Docket Item #3
BAR CASE # 2011-0214

BAR Meeting
September 7, 2011

ISSUE: Landscape Alterations

LOCATION: 113 South Lee Street

4 SECRET GARDEN PERGOLA
ELEVATION

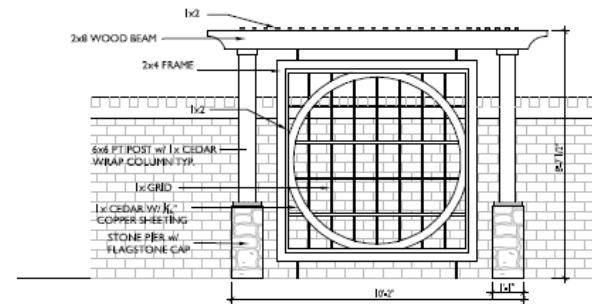
The proposed pergola will be located at the rear of the new, formal landscaped garden, inside the existing, six-foot high perimeter wall, approximately 111' back from the public sidewalk. Due to the varying street/courtyard grade differentials, the pergola will extend above the existing rear brick wall approximately 2'-7" and due to the increase in the interior grade, it will be approximately 8' higher than the front brick wall. However, due to the considerable distance from the front ROW and the deciduous and evergreen foliage proposed for the garden, during leaf season it will barely be visible from South Lee Street. Additionally, the pergola will have a footing, yet it will be detached from any other building or structure on the subject property and may be dissembled and removed in the future, if desired.

6 DRIVEWAY WITH COBBLE EDGE
PLAN

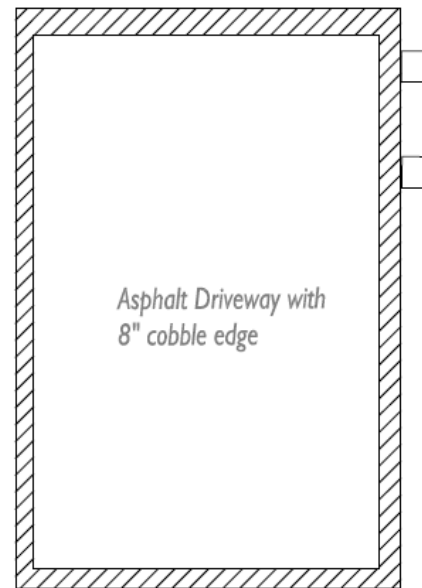
However, Staff finds it unfortunate that the applicant is retaining the existing asphalt paving surface for parking adjacent to the public sidewalk at this very historic house. Although a cobble border is being installed at the edge of the paving, it would be more historically appropriate and visually compatible if a cobble or paver brick were utilized throughout. Indeed, Staff suggests that it would be even more attractive if the applicant were to connect the adjacent brick sidewalk paving across the front of this property, in lieu of the existing section of concrete public sidewalk.
